SAM D11 Series Family Silicon Errata and Data Sheet Clarification

The SAM D11 Series family of devices that you have received conform functionally to the current Device Data Sheet (Atmel-42363H-SAM-D11-Datasheet_09/2016), except for the anomalies described in this document.

The following typographic corrections and clarifications are to be noted for the latest version of the Device Data Sheet (Atmel-42363H-SAM-D11-Datasheet_09/2016).

FIGURE 35-2 and 40-2: POR OPERATING PRINCIPLE:

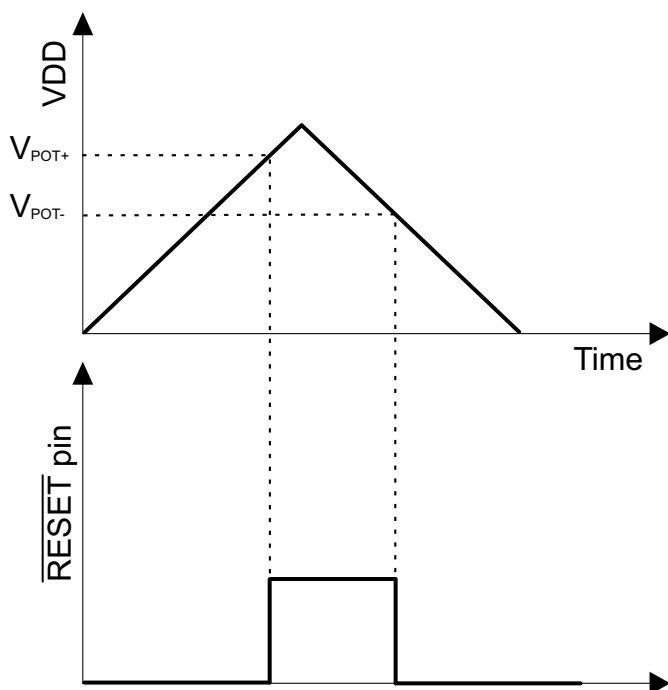
Figures 35-2, 35-3, 35-4, 40-2, 40-3, and 40-4 have an incorrect reset Polarity value. The corrected figures are as shown below:
